Murphy + Graves Project No. 1509

Project: North Park / New Highland Elementary

Field Report: # 1

#5:

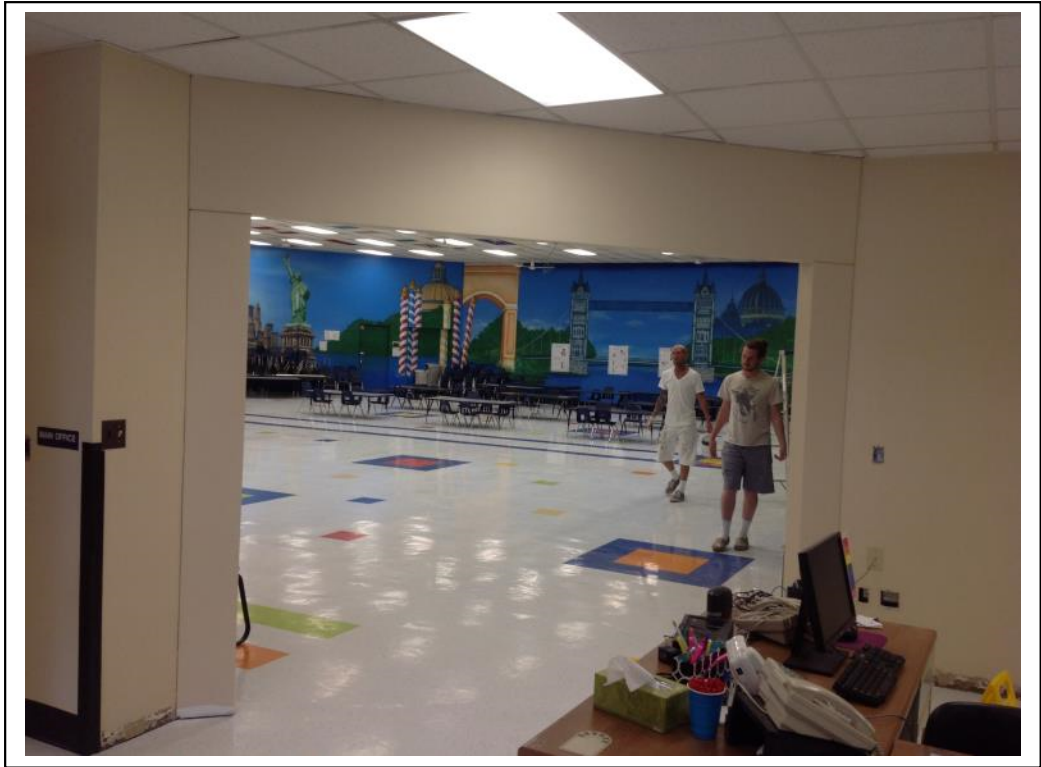
- General Contractor shall clean up concrete edges where new concrete butts existing concrete. Also remove expansion joint material and apply sealant at joints.

# 13

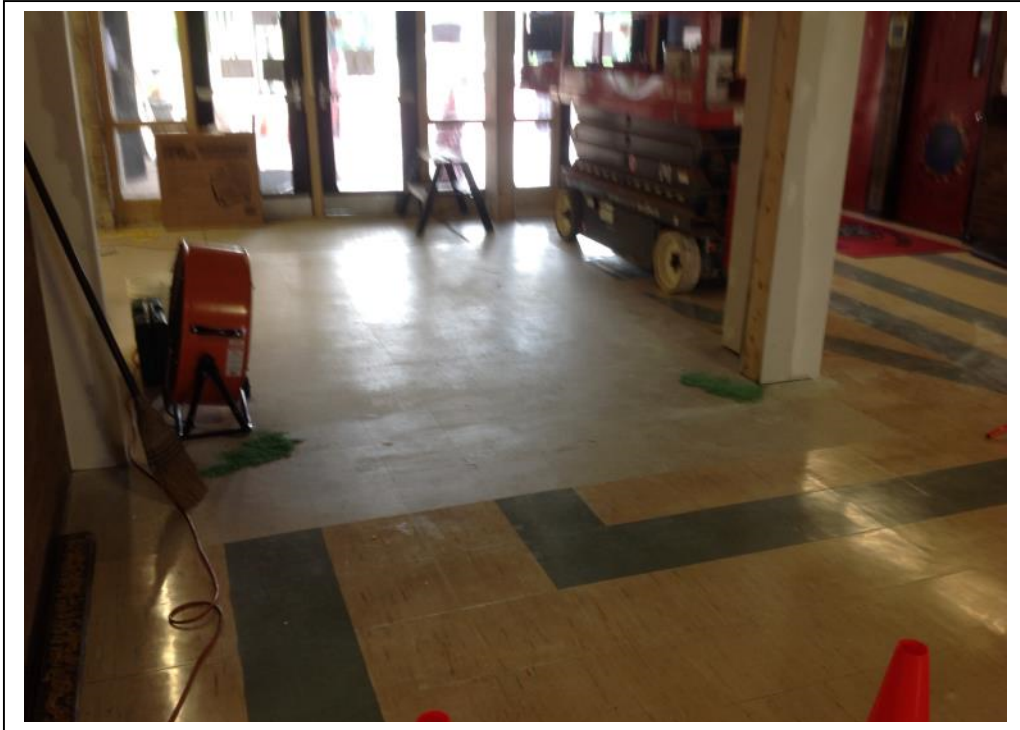
- If the work is incomplete on the VCT then MGT will review completion next time, however the General Contractor shall review the VCT floor tile at New Highland, any VCT that is damaged due to new wall or framing installation, see specifically photos 12 and 18. Contractor shall review the limits of replacing VCT per the layout plan on A 1.0.
